# HISTORIC AND DESIGN REVIEW COMMISSION

Agenda Item No: 23

**HDRC CASE NO:** 2015-094  
**ADDRESS:** 1203 E CROCKETT ST  
**LEGAL DESCRIPTION:** NCB 1373 BLK 1 LOT E 49 FT OF 9 & 10  
**ZONING:** RM4 H  
**CITY COUNCIL DIST.:** 2  
**DISTRICT:** Dignowity Hill Historic District  
**APPLICANT:** Aurora Morales  
**OWNER:** Aurora Morales  
**TYPE OF WORK:** Construct front porch, window modifications and front door installation  
**REQUEST:**

East Elevation

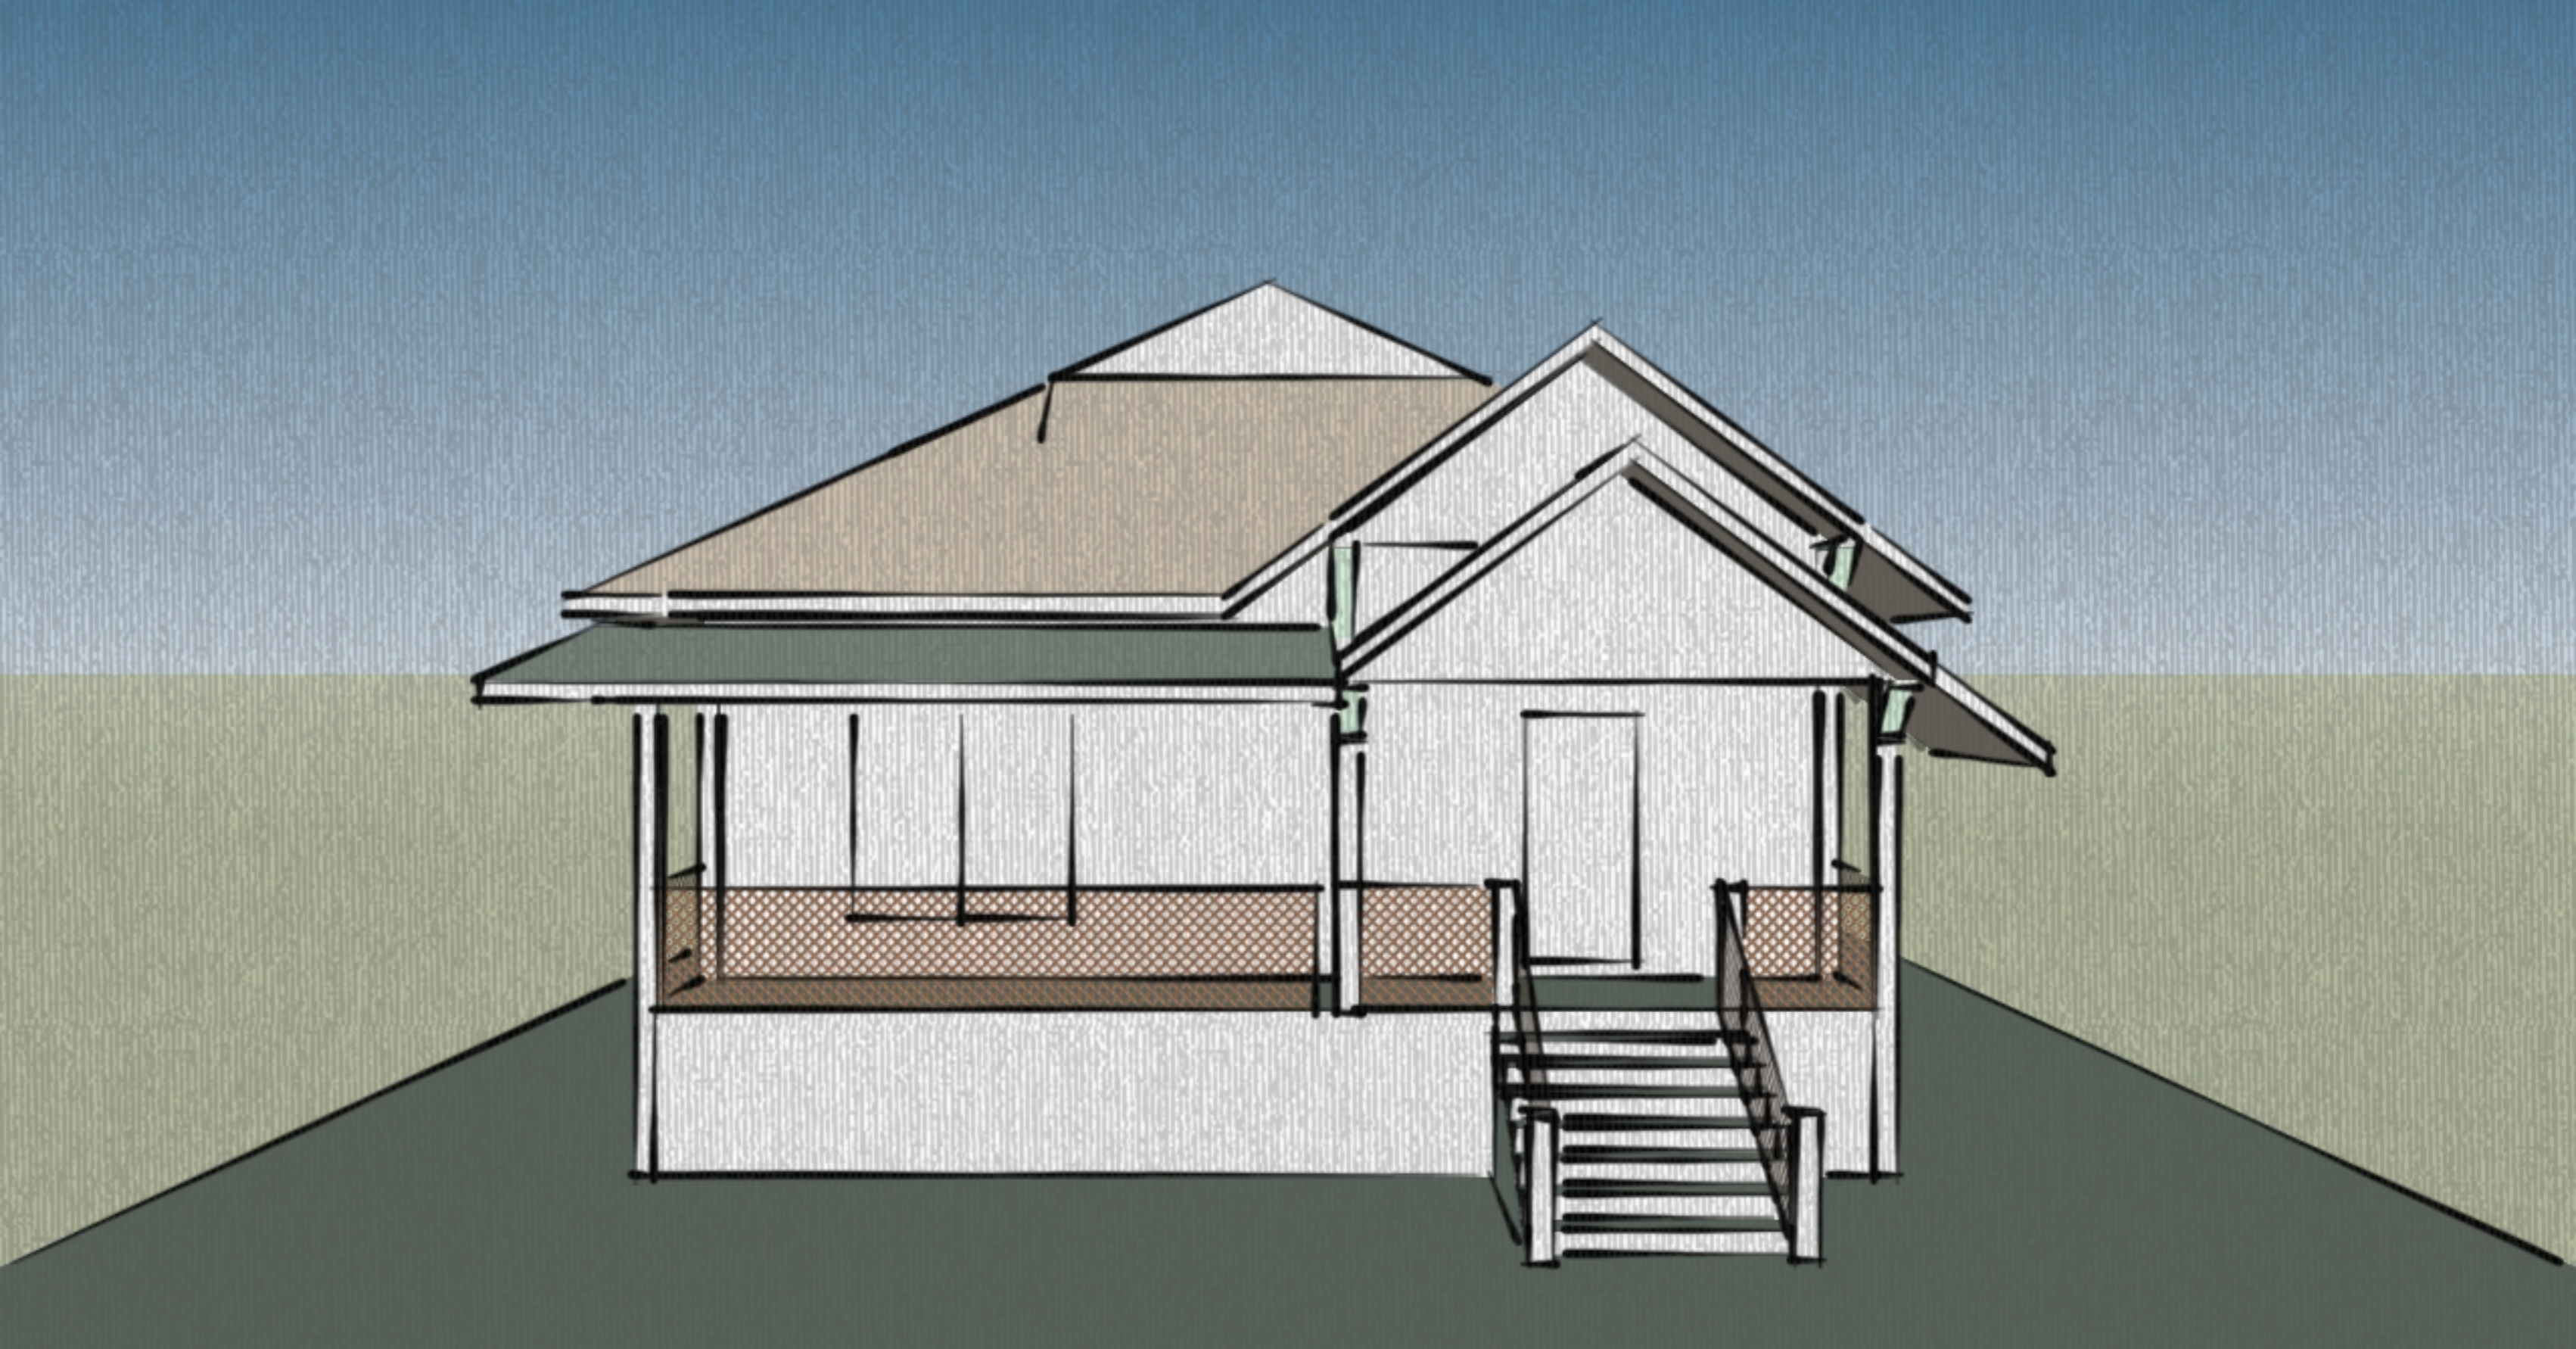
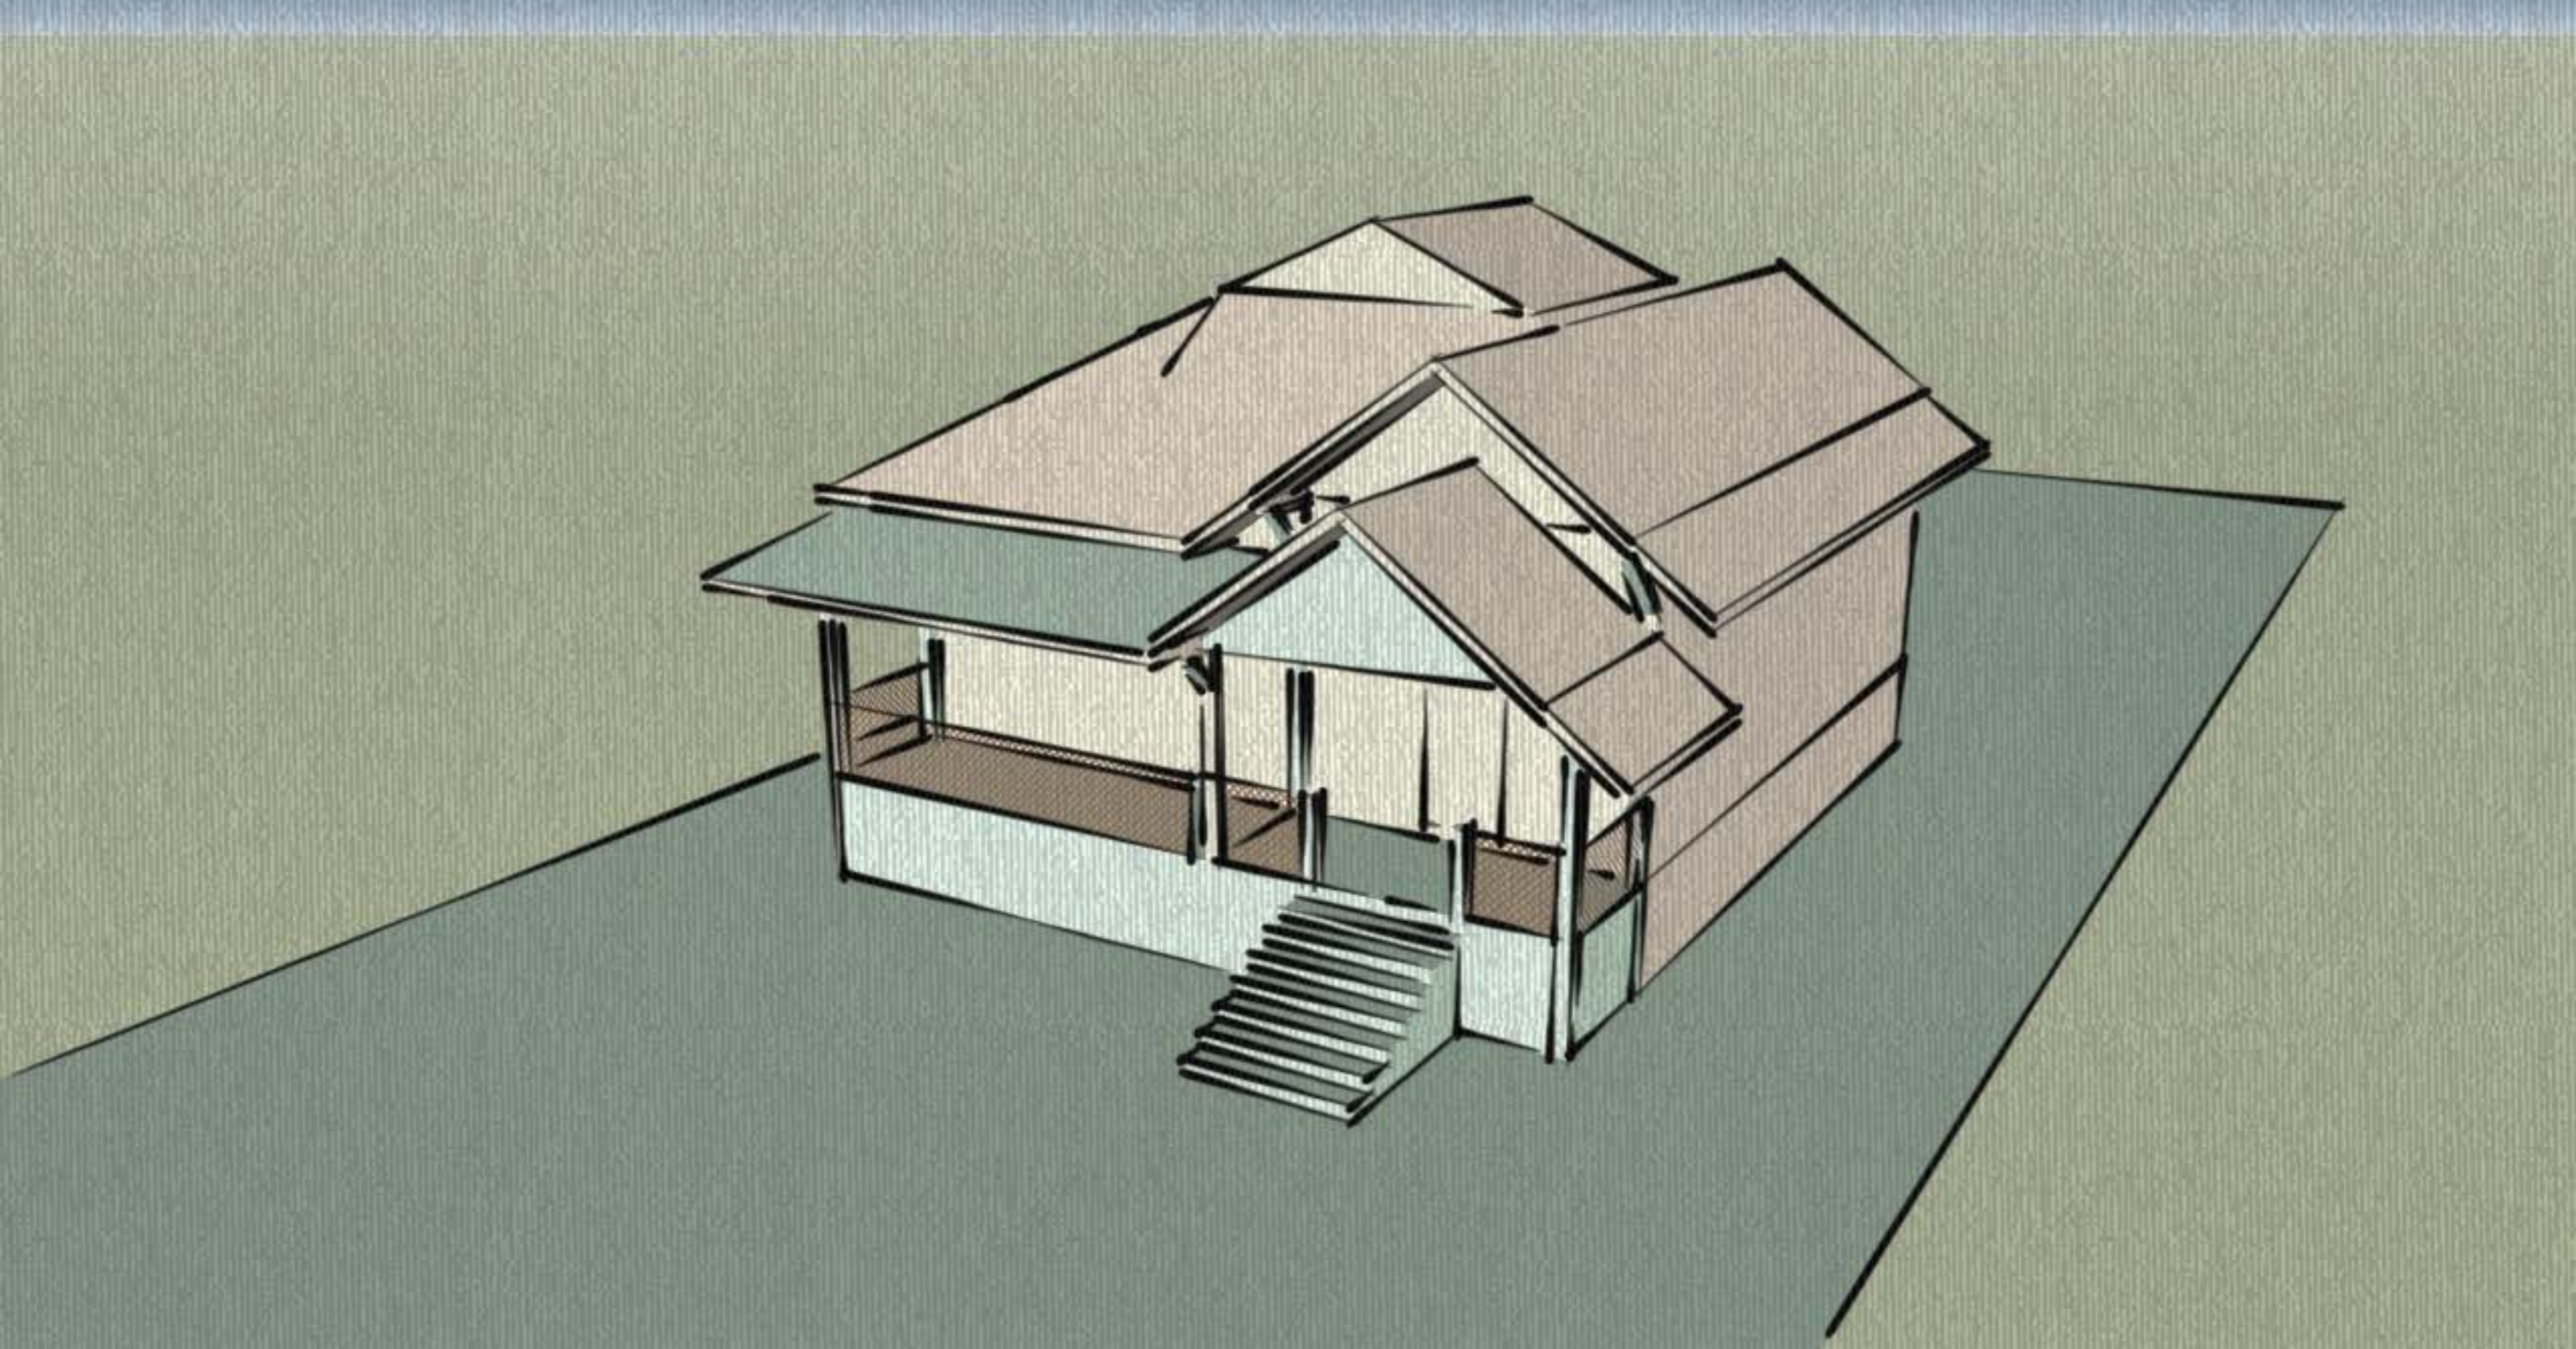
- e. Consistent with the Guidelines for Exterior Maintenance and Alterations, existing window openings should be preserved. In addition, non-historic windows should be replaced with new windows that are typical of the architectural style of the building. Although the proposed window modifications will alter the existing window opening, this opening is not of historic age and the proposed enlargement will not cause an adverse effect. However, the proposed multi-light windows are not typical of the Craftsman style and are not consistent with the guidelines. Using one-over-one wood windows would be more appropriate.

- h. The Guidelines for Exterior Maintenance and Alterations recommend that doors are replaced in-kind when possible when deteriorated beyond repair. The proposed front door is not in keeping with the architectural style of the home and is not a commonly found type of door in a historic district.

1. Staff recommends approval of item 1 based on findings a-g with the stipulation that the new windows are one over one wood.
2. Staff does not recommend approval of item 2 as submitted based on findings h. Staff recommends that a historically appropriate front door is installed or that a wooden screen appropriate for the style of the house is used instead.
